PRCOM20224906

REVISDE 6/22/2023

I-470 BUSINESS & TECHNOLOGY CENTER, LOT 7

ISSUED FOR PERMIT OWNER REVISIONS

FINAL DEVELOPMENT PLAN

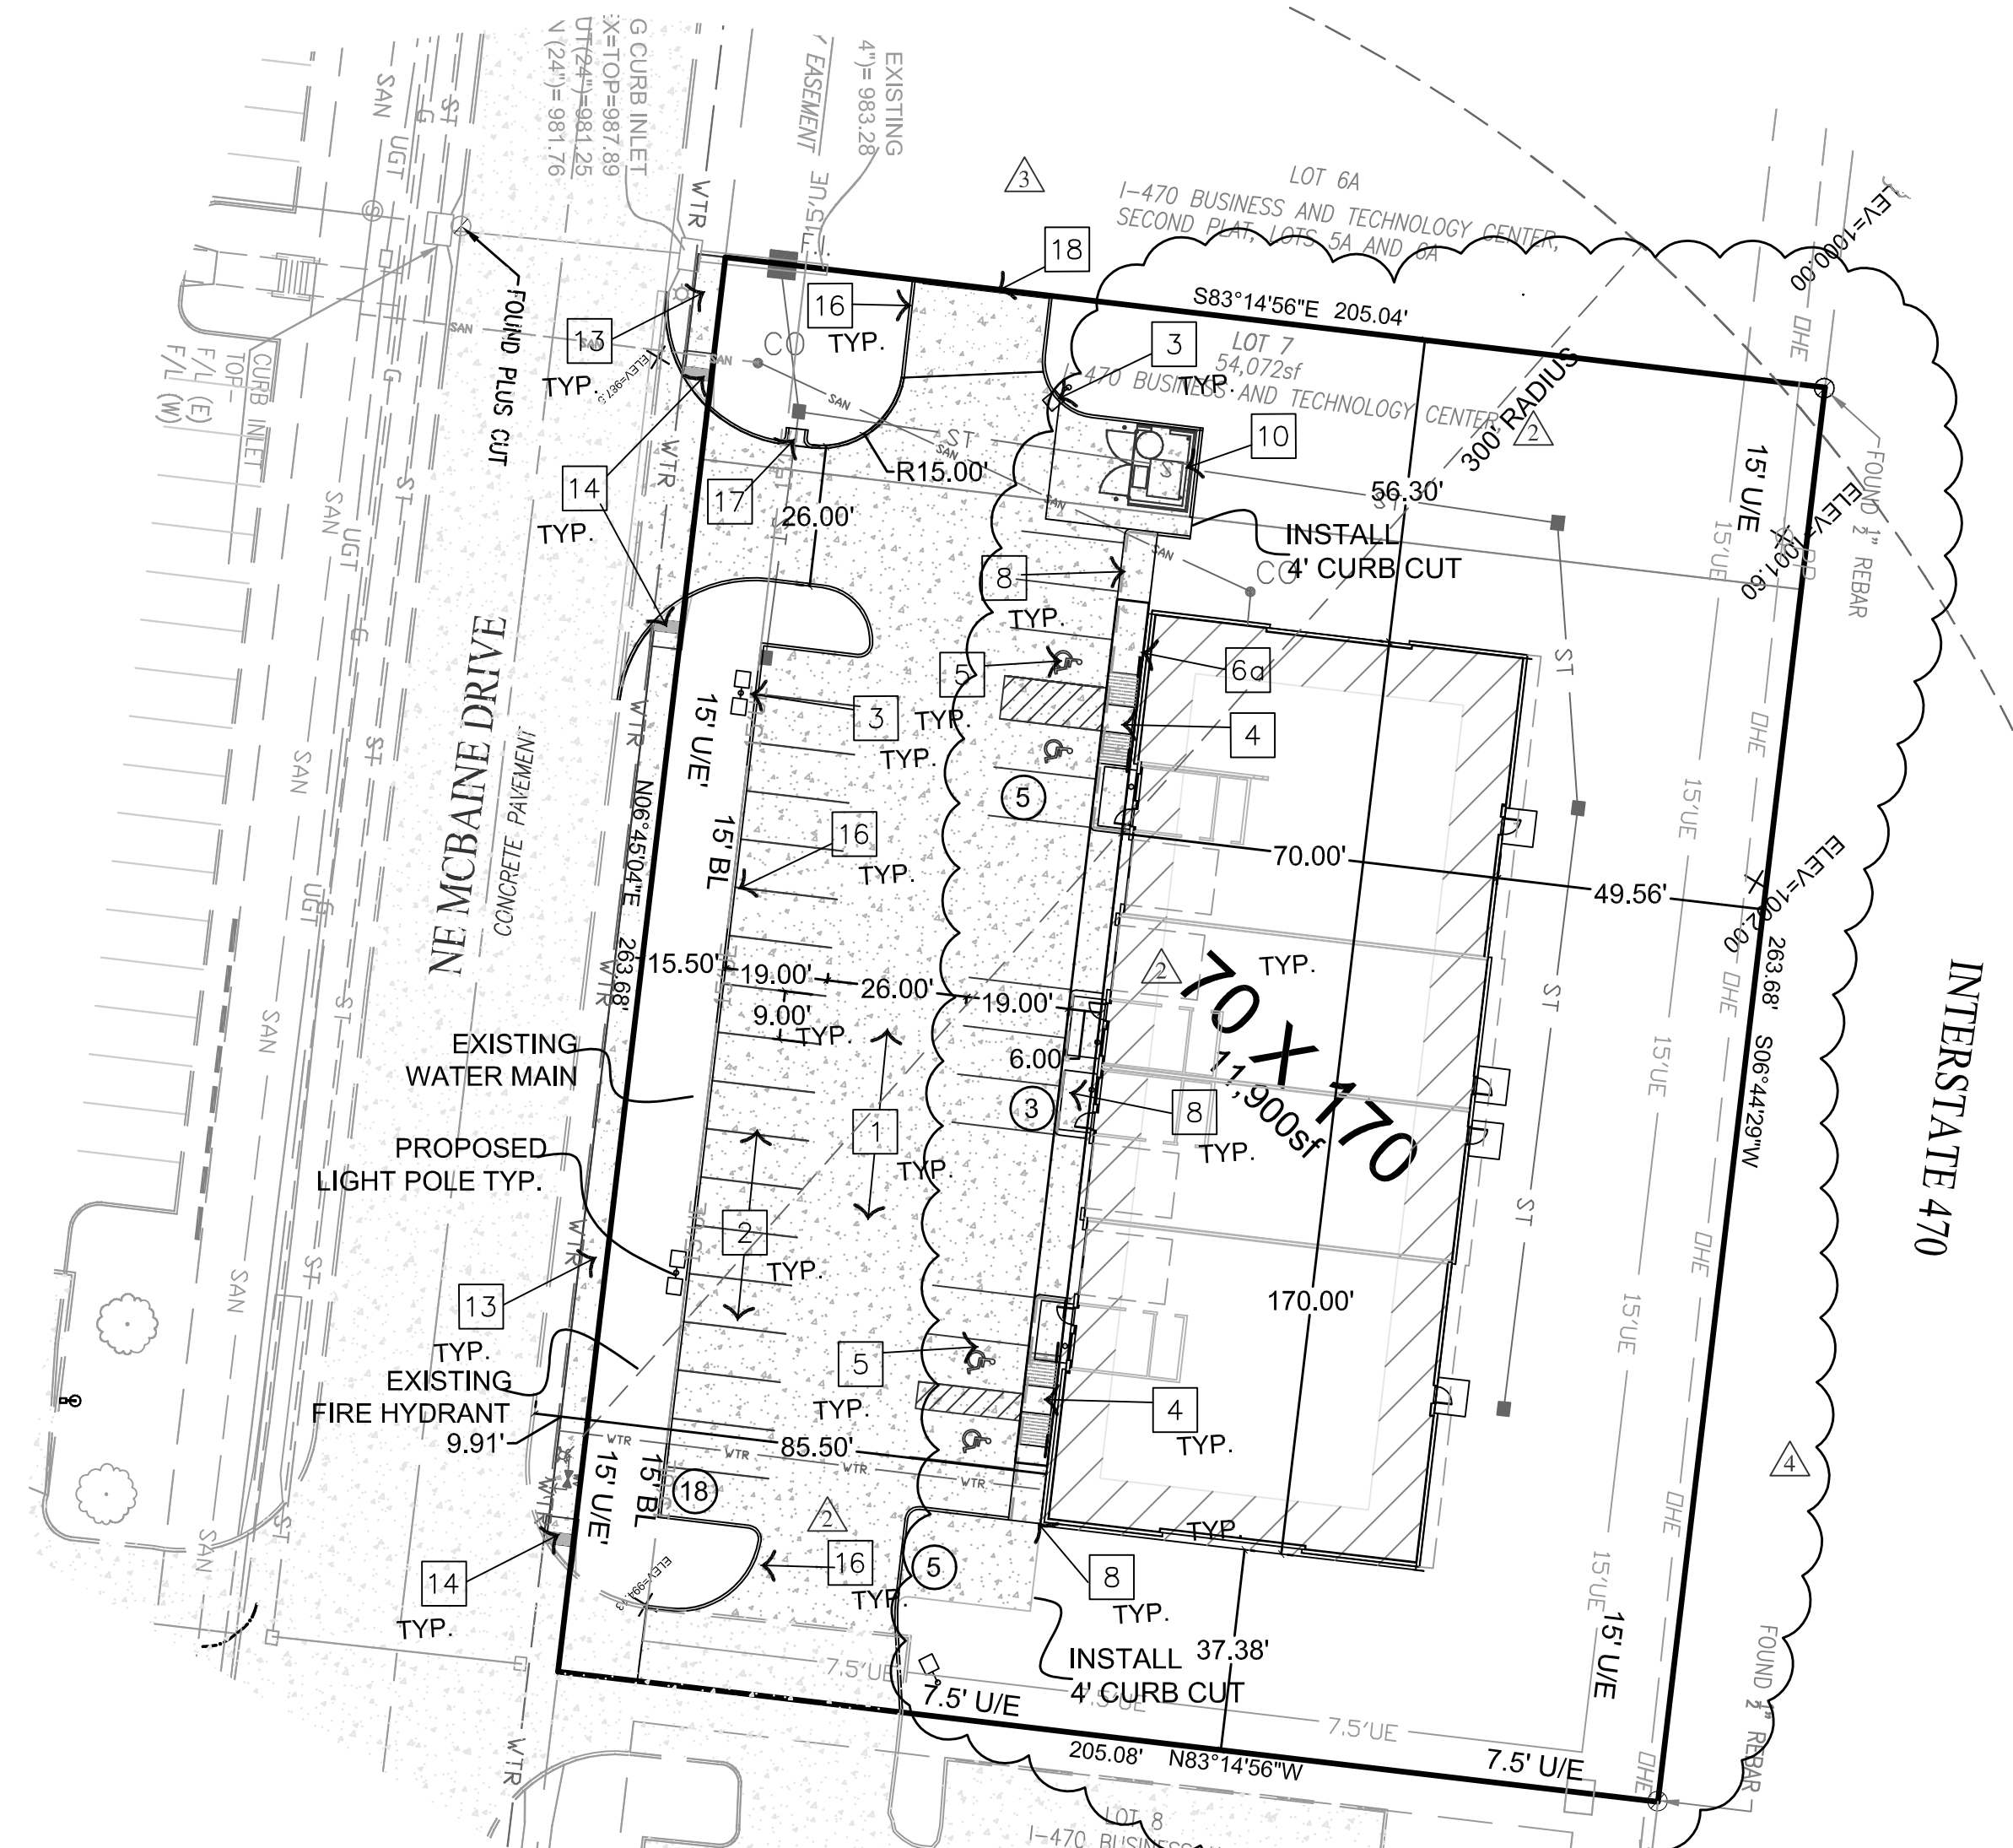
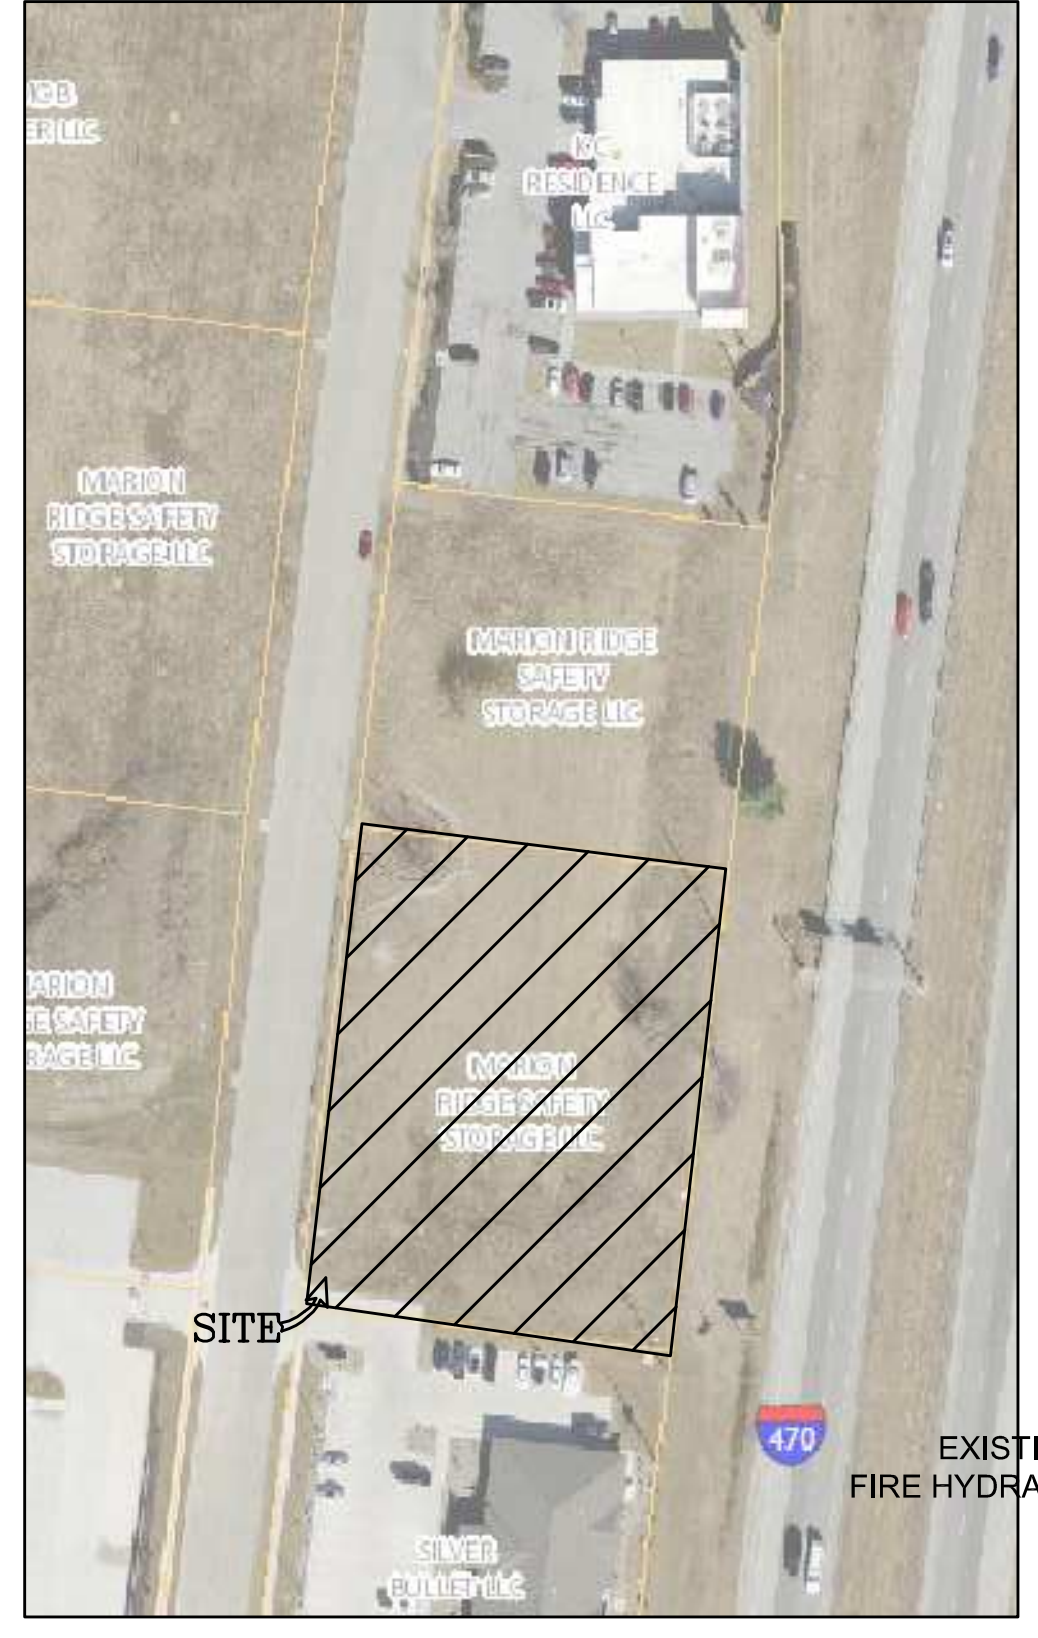
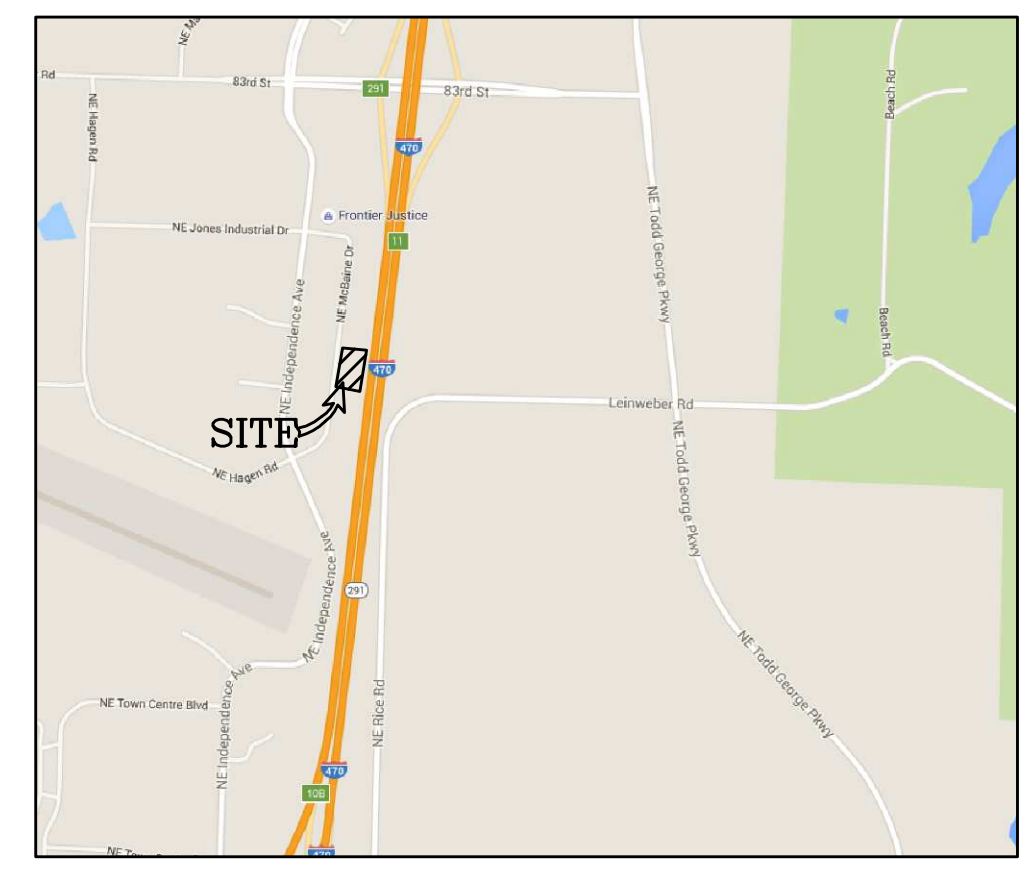
REVISOR'S NOTE:
REMOVED REAR ACCESS ROAD
REMOVED TRASH ENCLOSURE

SITE LANDSCAPING PLAN

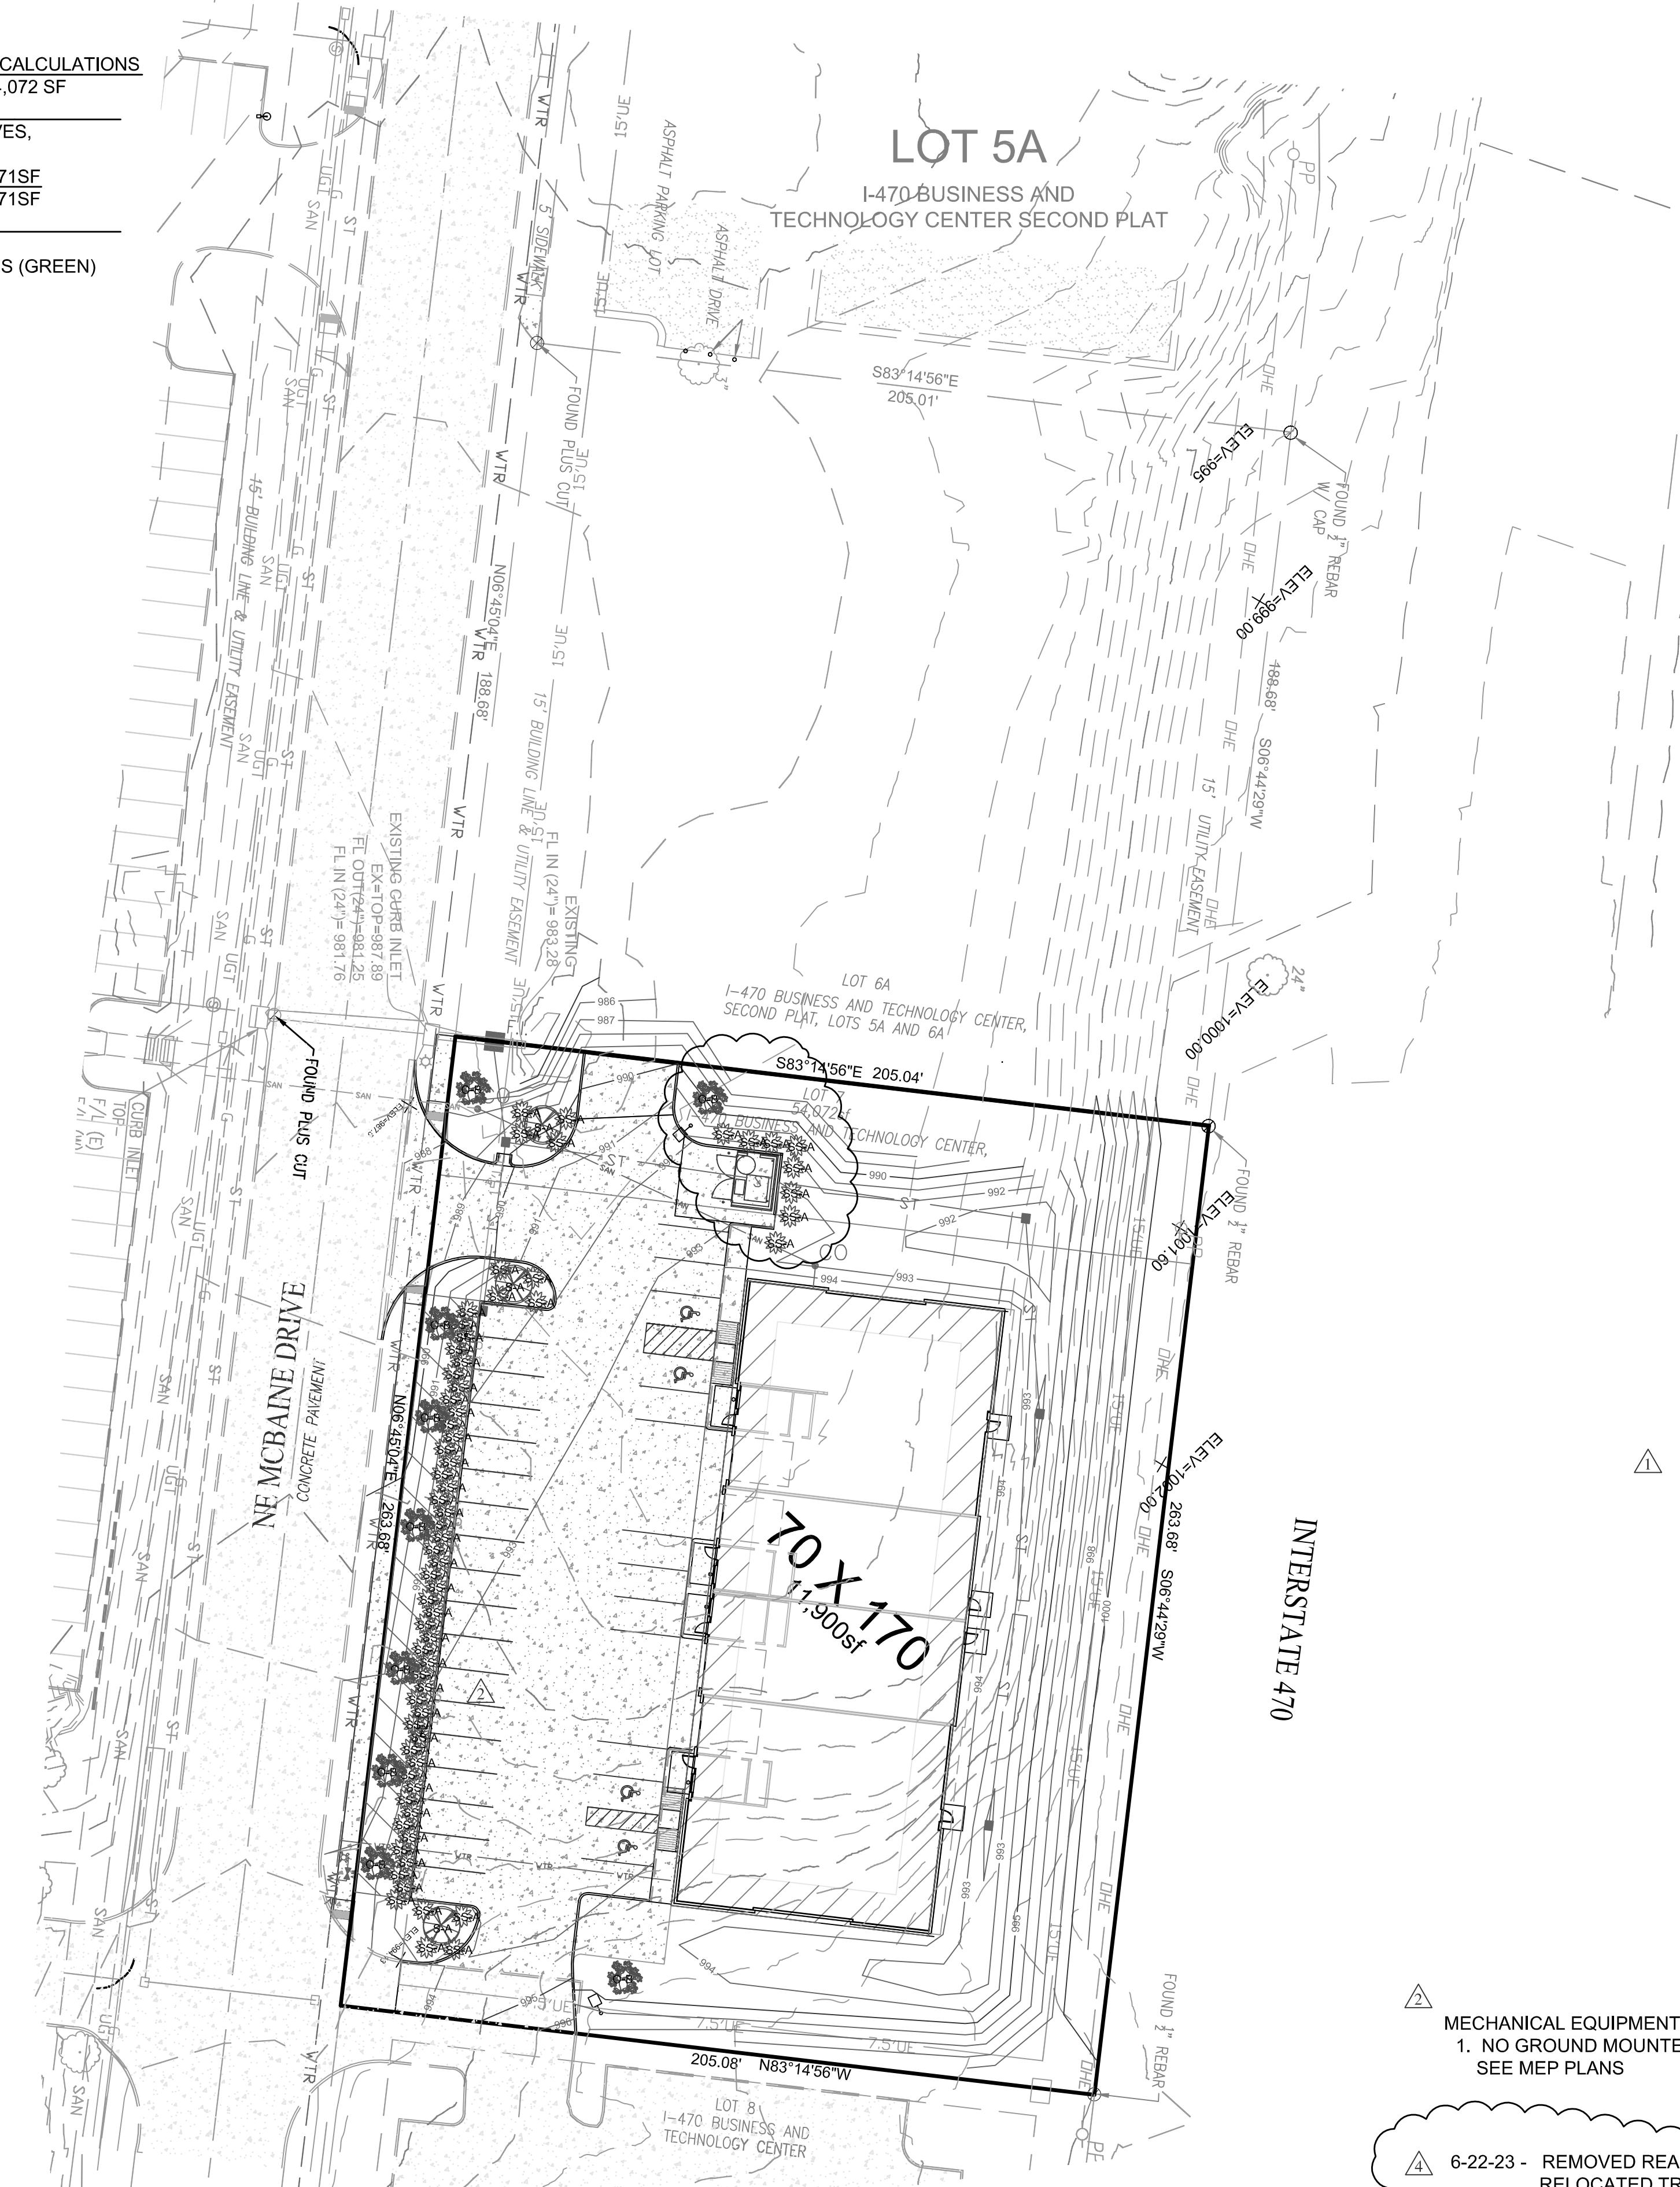
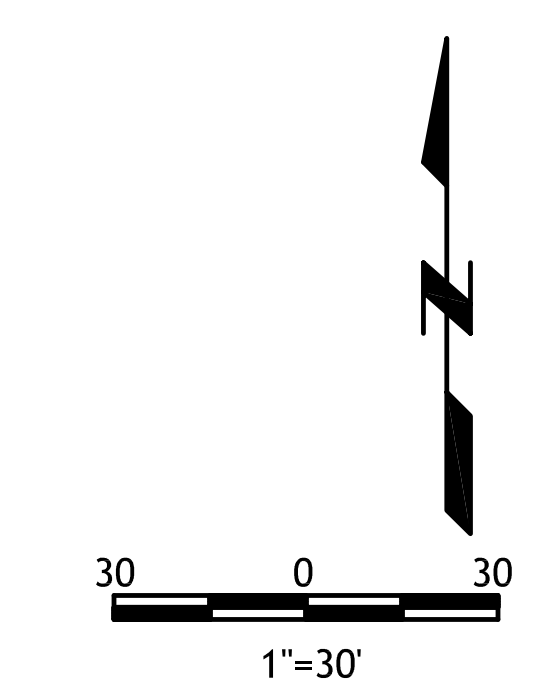
△ 6-22-23 - REMOVED REAR ACCESS ROAD, RELOCATED TRASH ENCLOSURE, REVISED PARKING ALONG FRONT OF BUILDING
